UNT SYSTEM™

DATE: February 28, 2025
TO: Potential Respondents
FROM: Carrie Stoeckert—Construction Contract Expeditor III
SUBJECT: Addendum #1
RFQ752-25-1004CS
Chilton Hall 111 Renovation

ADDENDUM NO. 01

PROJECT: Chilton Hall Level 1 Renovation
HE0569.240100

LEVEL 1 FLOOR PLAN - MECHANICAL

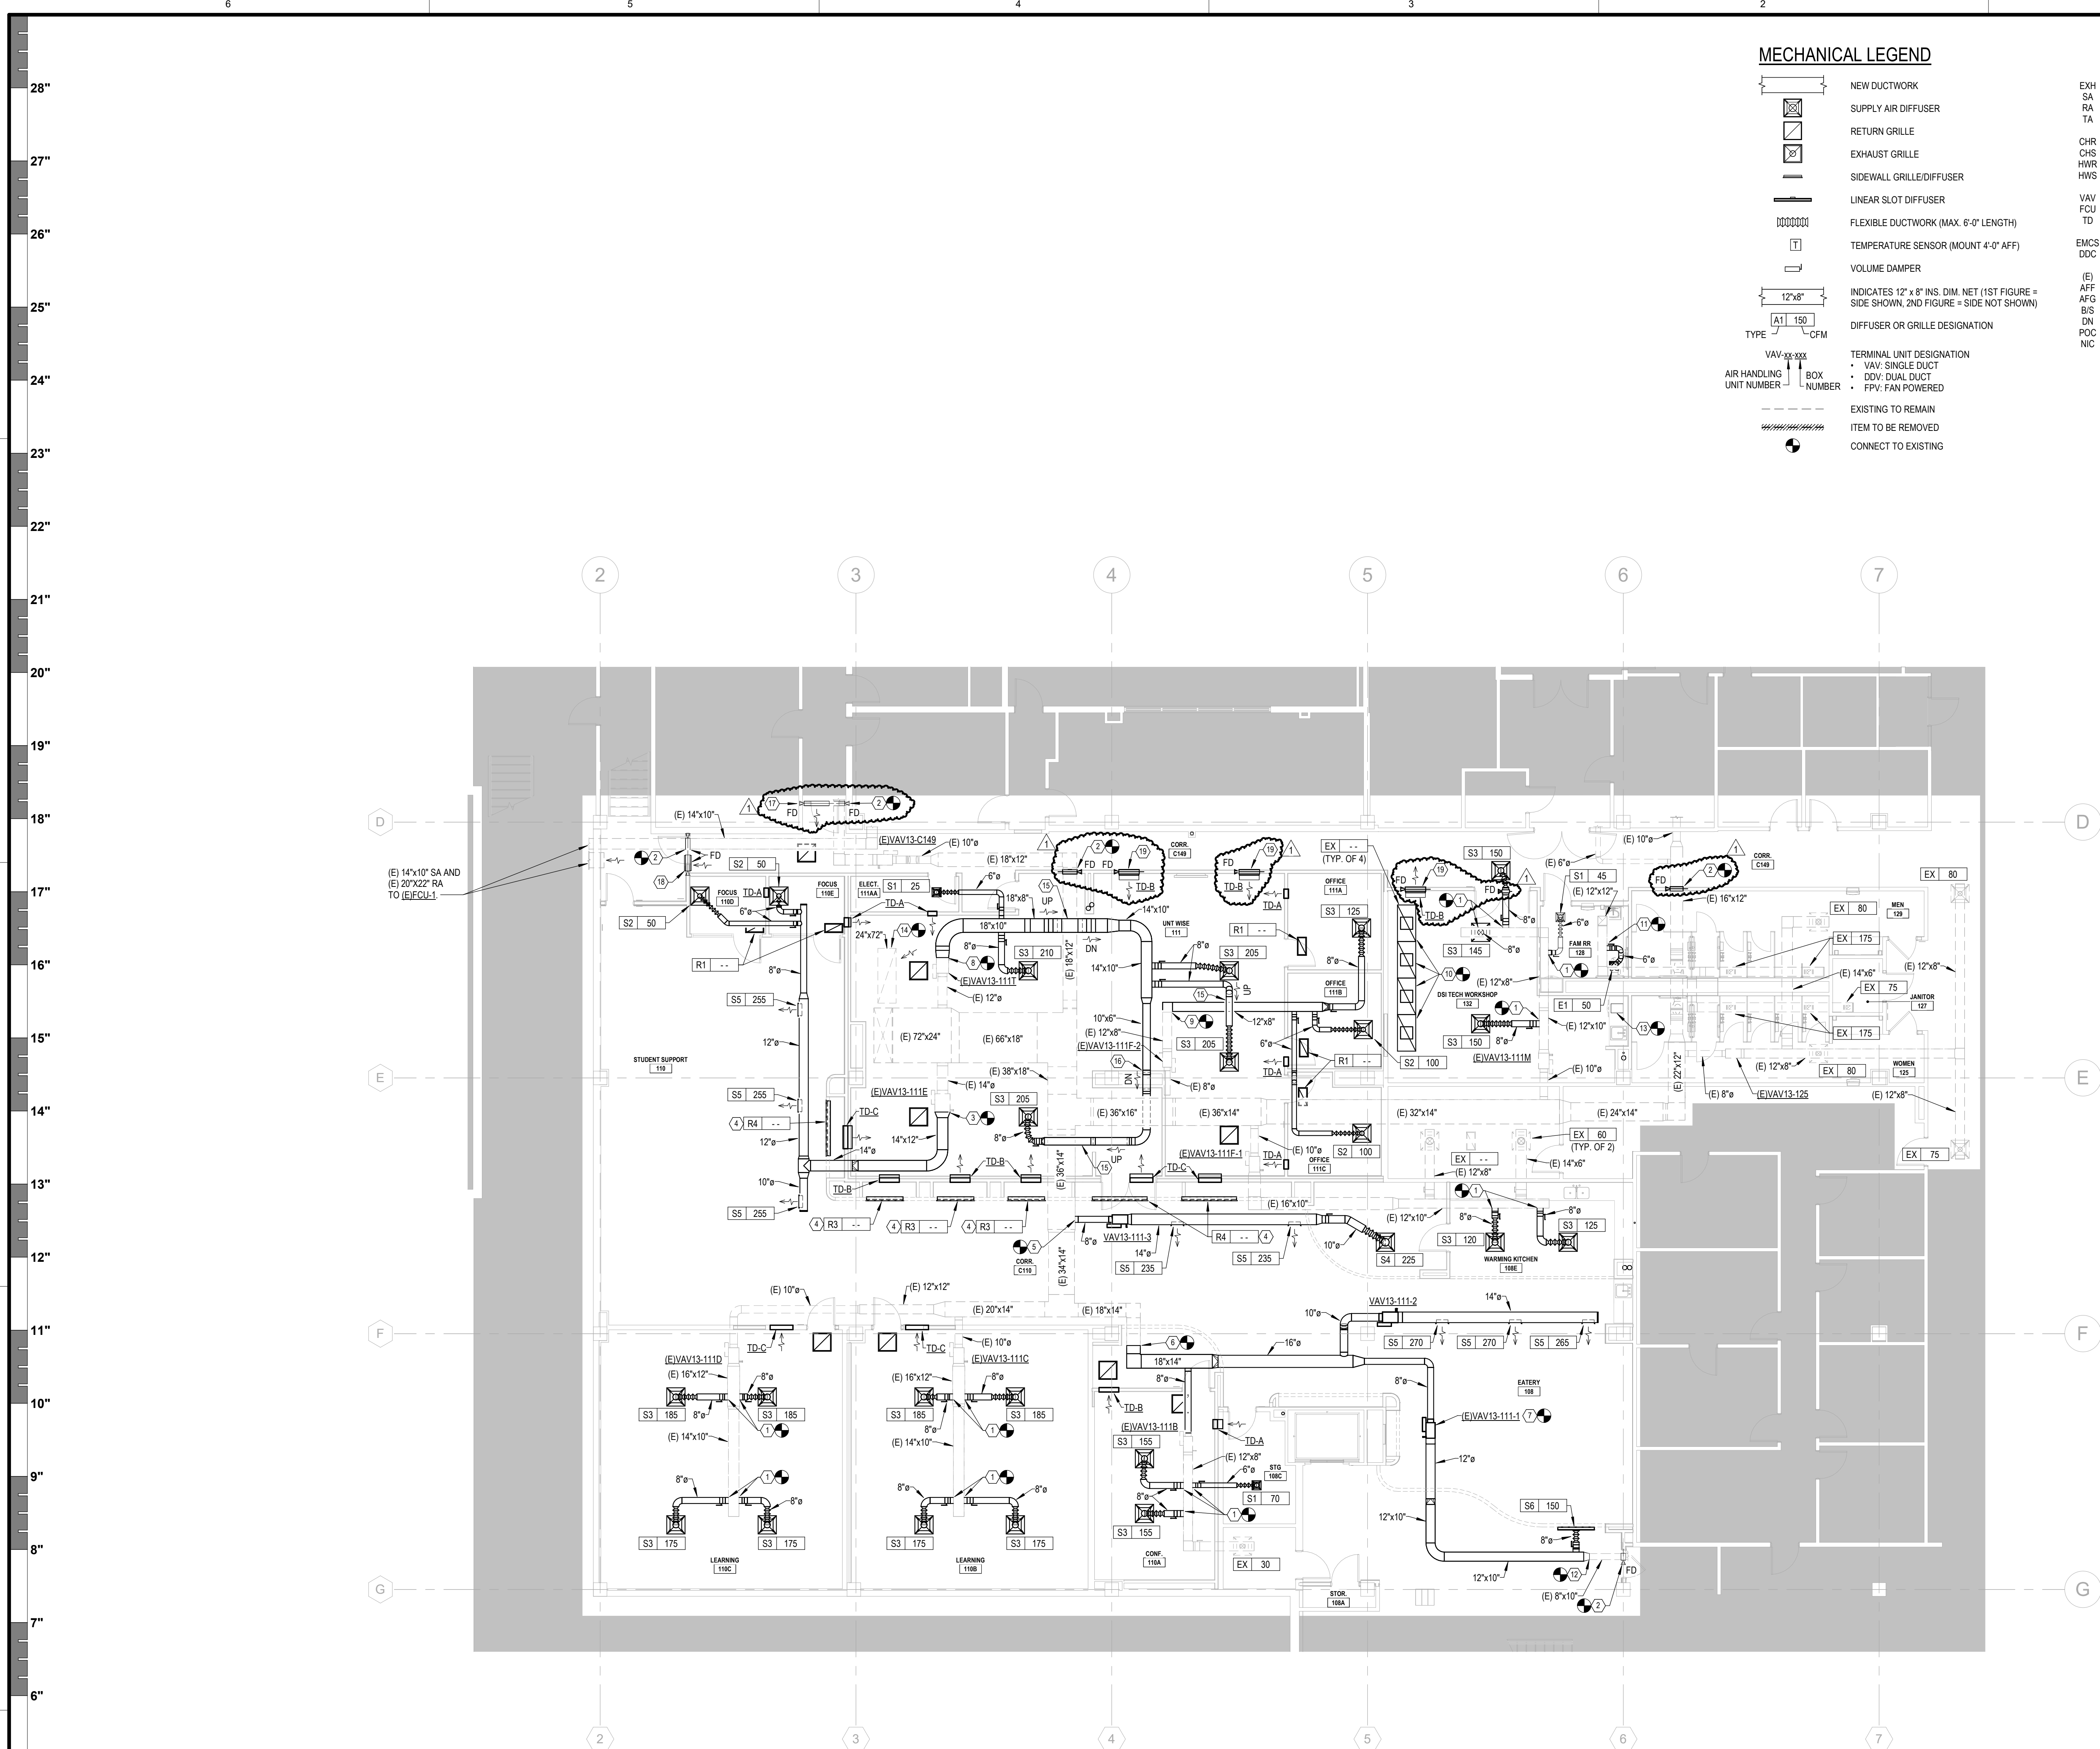
1.23	<u>M101</u>
	A. ADDED: Fire dampers to existing ductwork at the new corridor rated partitions. B. ADDED: Fire dampers to the transfer air devices at the new corridor rated partitions. C. MODIFIED: Notes by symbol #17. D. ADDED: Notes by symbol #19. E. ADDED: Sheet notes #5 and #6.

- CONNECT NEW SUPPLY AIR BRANCH DUCT TO (E) SUPPLY AIR DUCTWORK AND ROUTE ABOVE CEILING AS INDICATED TO NEW AIR DEVICE.
- PROVIDE AND INSTALL FIRE DAMPER IN (E) DUCTWORK AT PENETRATION OF NEW FIRE RATED PARTITION. CONFIRM LOCATION AND SIZE OF (E) DUCTWORK ON SITE.

- OFFSET DUCTWORK DOWN AND ROUTE UNDER DUCTWORK AS REQUIRED.
- PROVIDE 32"x20" TA OPENING WITH FIRE DAMPER ABOVE CEILING AS HIGH AS POSSIBLE.
- PROVIDE 20"x22" TA OPENING WITH FIRE DAMPER ABOVE CEILING AS HIGH AS POSSIBLE.

- TRANSFER AIR DUCT ABOVE THE CEILING WITH TRANSFER AIR SILENCER. REFER TO TRANSFER AIR DEVICE SCHEDULE ON SHEET M301 FOR MORE INFORMATION ON TRANSFER AIR DEVICE. PROVIDE AND INSTALL FIRE DAMPER AT RATED PARTITION PENETRATION.

LEVEL 1 FLOOR PLAN - HYDRONIC AND CONTROLS

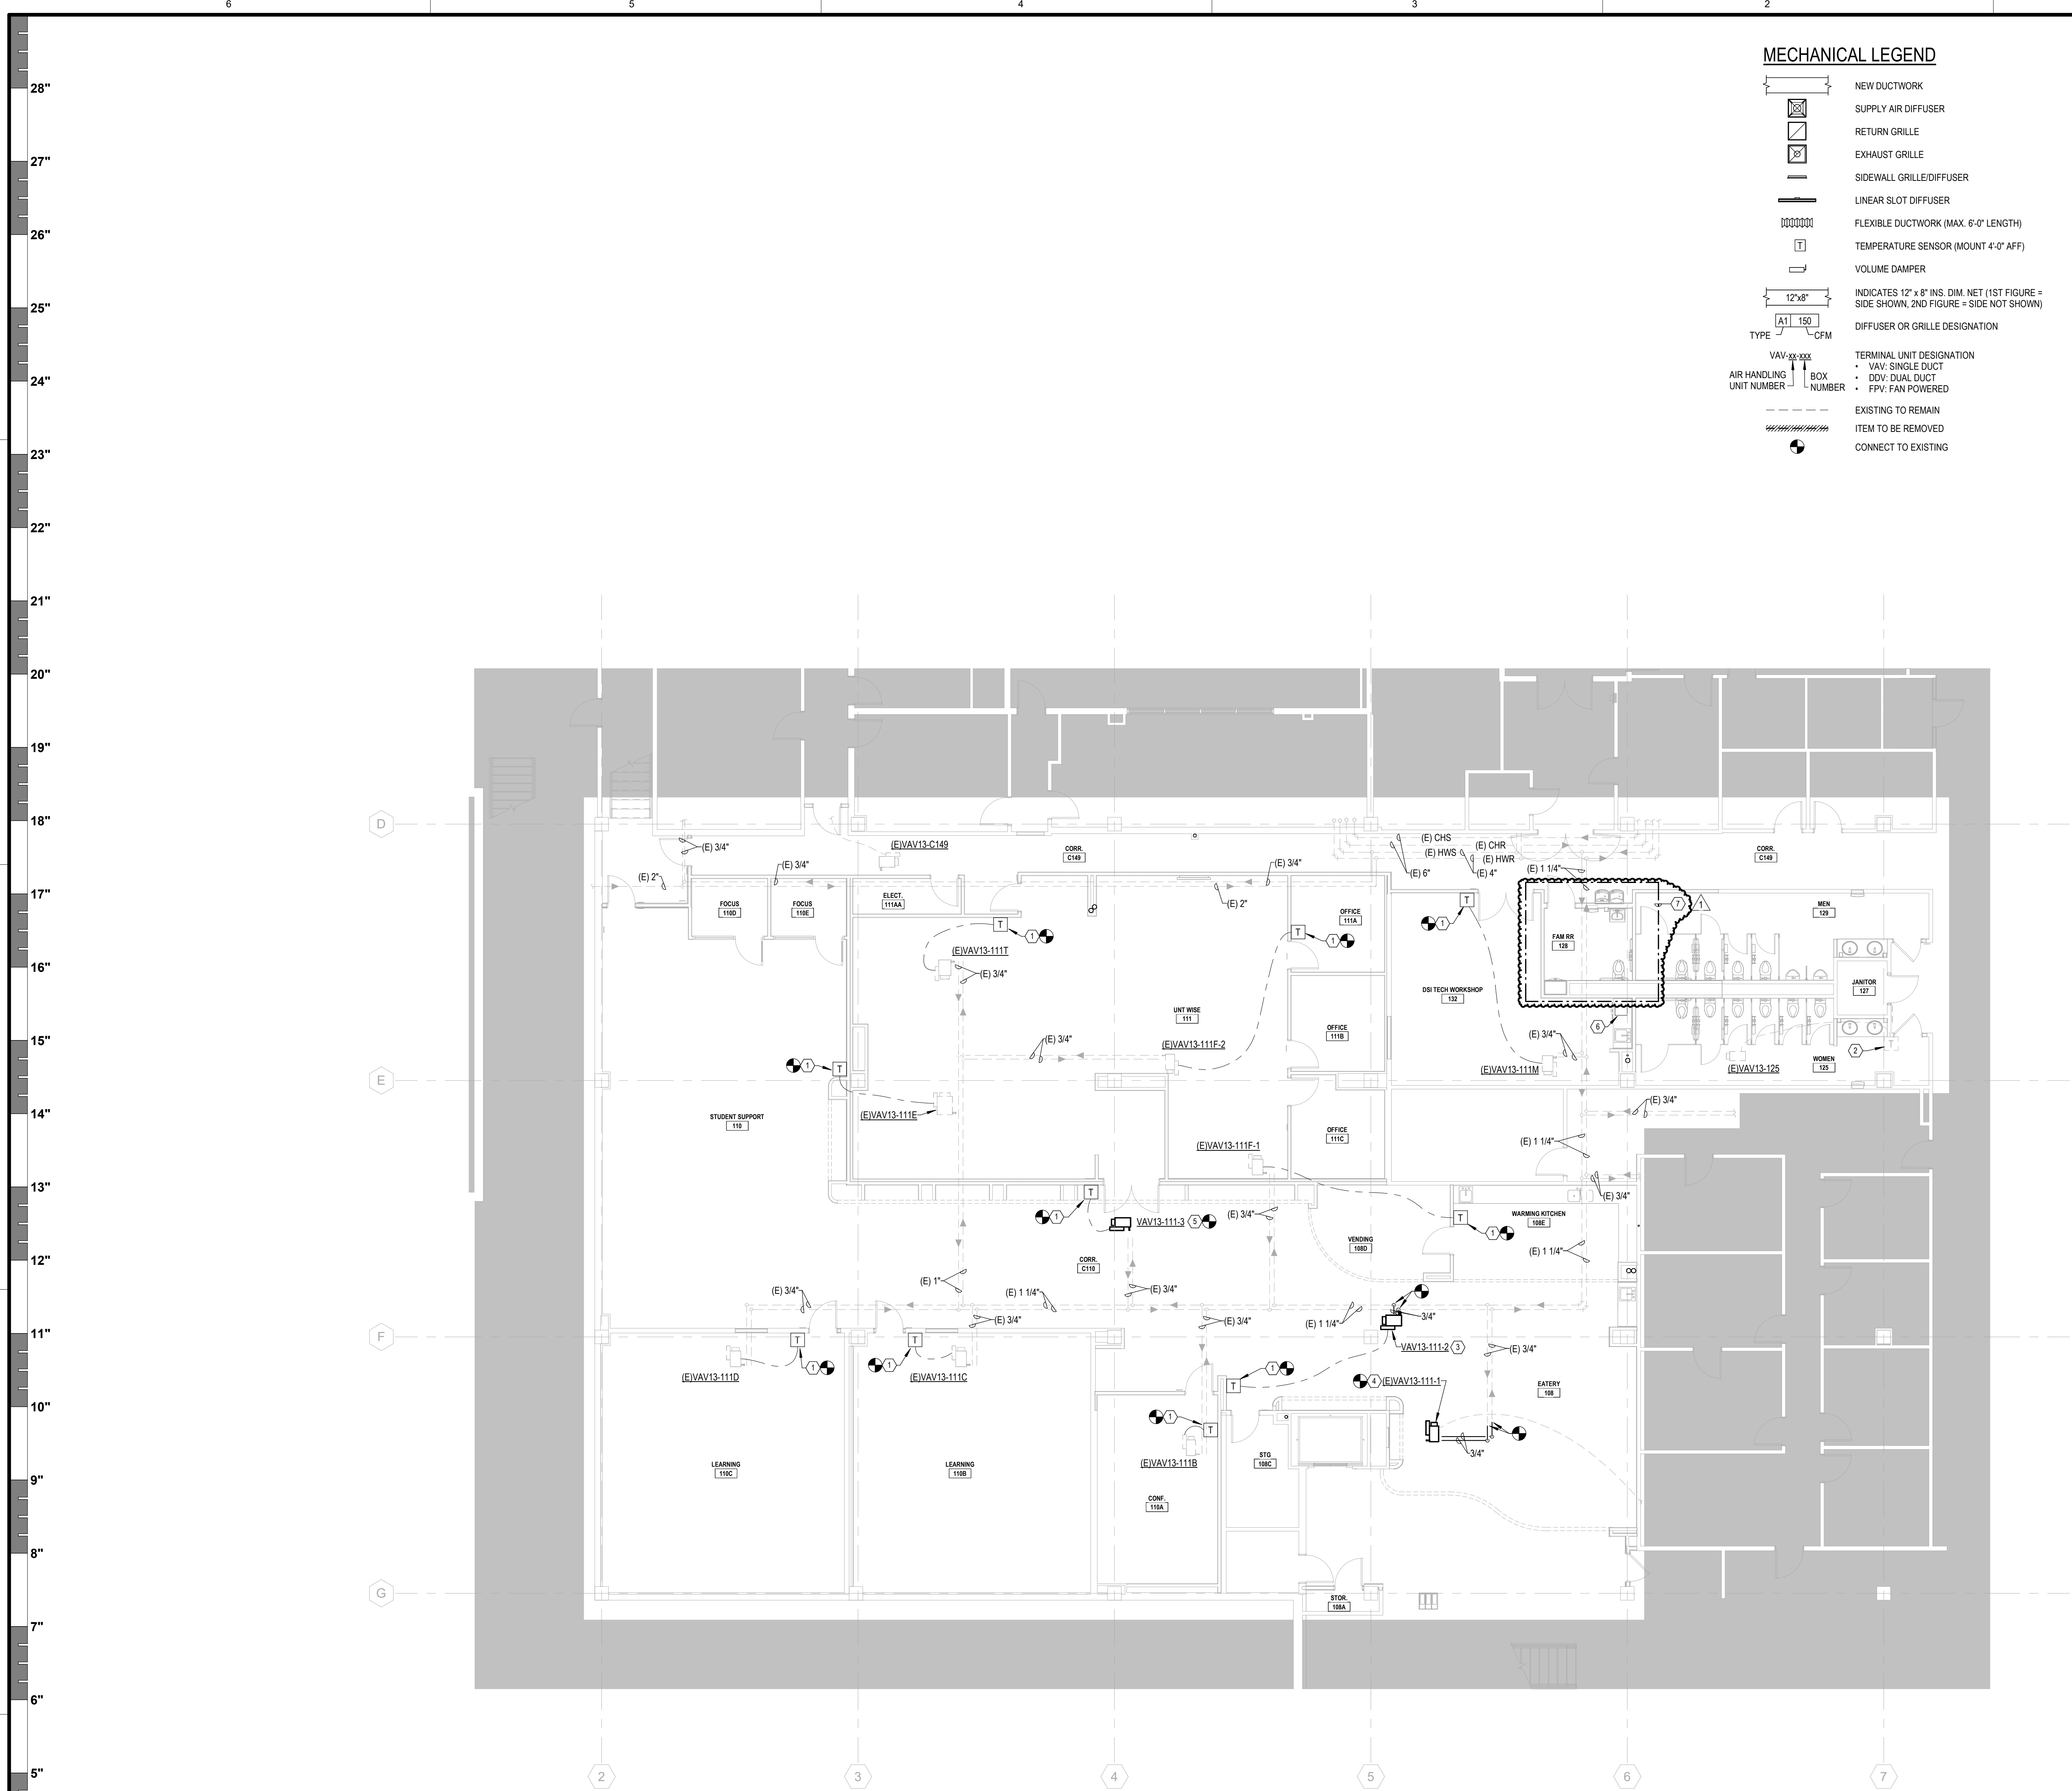
1.24	<u>M201</u>
	A. ADDED: Location of abandoned hydronic piping to be capped. B. MODIFIED: Sheet notes #1. C. ADDED: Notes by symbol #7. D. ADDED: Sheet notes #4 and #5.

- REINSTALL (E) RELOCATED TEMPERATURE SENSOR.
- (E) TEMPERATURE SENSOR TO REMAIN.
- CONNECT 3/4" HWSHWR TO (E) 1-1/4" HWSHWR AND ROUTE TO NEW VAV13-111.2. PROVIDE AND INSTALL ISOLATION SHUT-OFF VALVES PRIOR TO FINAL CONNECTION TO (E) 1-1/4" HWSHWR MAINS.
- CONNECT 3/4" HWSHWR TO (E) 3/4" HWSHWR AND ROUTE TO RELOCATED (E) VAV13-111.1. EXTEND AND RECONNECT (E) CONTROL WIRING TO (E) VAV13-111.1.
- CONNECT (E) 3/4" HWSHWR TO NEW VAV13-111.3.
- (E) RELOCATED SPACE DEHUMIDIFIER, REFER TO M101 FOR ADDITIONAL INFORMATION.
- EXISTING ABANDONED HYDRONIC PIPING ABOVE CEILING IN THIS AREA SHALL BE CAPPED WATER-TIGHT.
